# International Aero Engines SERVICE BULLETIN

ENGINE - FUEL AND CONTROL - TO PROVIDE A NEW A5SCN14B/S ELECTRONIC ENGINE CONTROL (EEC)

Mar.6/00

**V2500-ENG-73-0160**

Location of the Electronic Engine Control (EEC)  
Figure 1

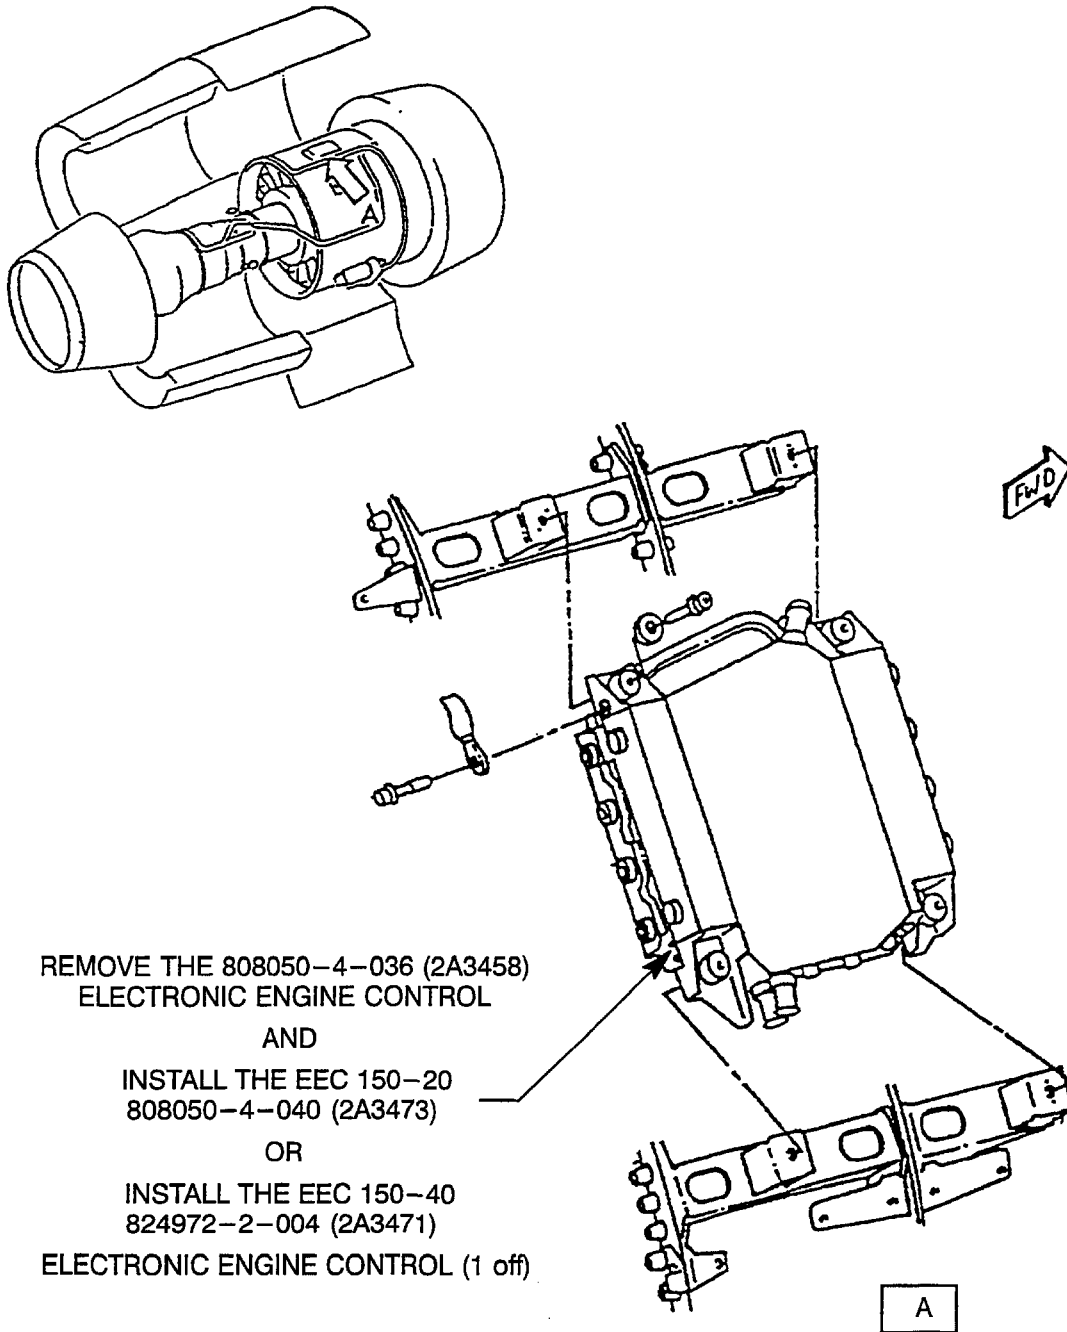
- (1) Remove the Old P/N (Table 4) Electronic Engine Control by the procedure given in Reference (4), Chapter/Section 73-22-34, Removal Installation. Refer to Figure 1.

- (1) Do a modification of the Old P/N (Table 4) Electronic Engine Control (See Reference (4), Chapter/Section 73-22-34, Fig/Item No. 01-280) and reidentify by the procedures given in Reference (2).

- (1) Install the New P/N (Table 4), Electronic Engine Control (1 off) by the approved procedure given in Reference (4), Chapter/Section 73-22-34, Removal/Installation.

Family Tree - Electronic Engine Control (EEC)  
Ref. Catalog Sequence No. 73-22-34. Fig. 01 Item 280  
Figure 2 (Sheet 2)

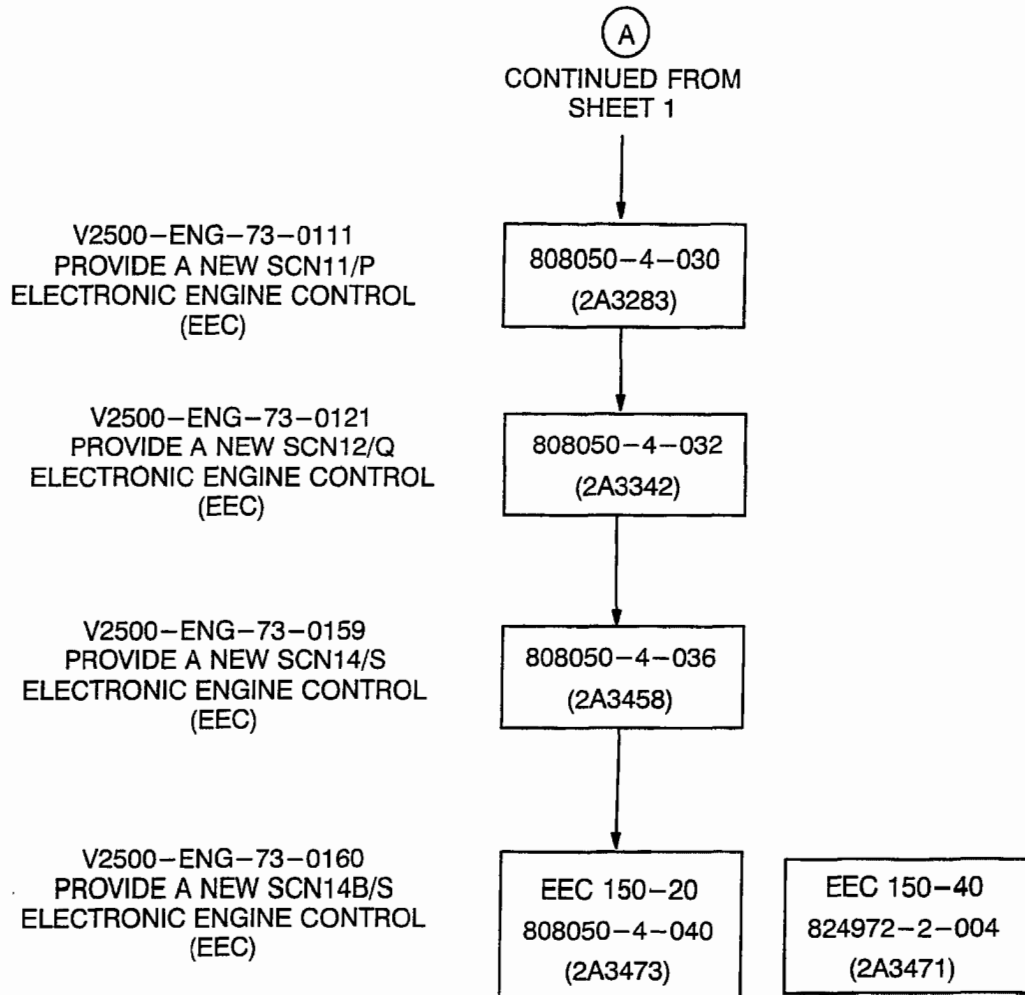
808050-4-040 1 (2A3473) (73-22-34)		Control, Electronic Engine (150-20)		808050-4-036 (1D)(A) (2A3458) (01-280)	
824972-2-004 1 (2A3471) (73-22-34)		Control, Electronic Engine (150-40)			(A)

(1D) The new part can be obtained through modification by the approved procedure in Reference (2). Purchase the new parts from or return the old parts for modification to one of the approved vendors listed in Paragraph 2. B. in the Accomplishment Instructions.
